# Economic and Social Council

### Amendments to Resolution No. 61

#### Addendum

## II. Draft Chapter 20 B on special provisions applicable to river-sea navigation vessels

(Load line according to International Convention on Load Lines, 1966)

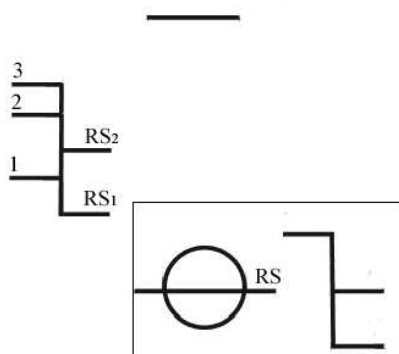
20B-5.1.4 Vessels navigating at sea shall carry a load line mark according to the International Convention on Load Lines, 1966.

Sternwards off the draught mark the following marks shall be placed:

- (i) marks for navigation on inland waterways of zones 1, 2 and 3 in accordance with 4-4.1.2;
- (ii) a measurement mark in accordance with the requirements of the Convention on the Measurement of Inland Navigation Vessels, if the vessel is measured in accordance with it;
- (iii) marks for navigation in sea areas with seawater, where the vessel is allowed for navigation with a wave height lower than in the given zones, e.g. for a vessel in zone RS 3,5 — zones RS 3,0 and 2,0.

The diagram of the load line is shown on the figure:

RS<sub>1</sub>, RS<sub>2</sub> — lines corresponding to the maximum draught for navigation in sea areas with a wave height lower than in the main navigation zone;

1, 2, 3 — lines corresponding to maximum draught for navigation on inland waterways of zones 1, 2 and 3 respectively.
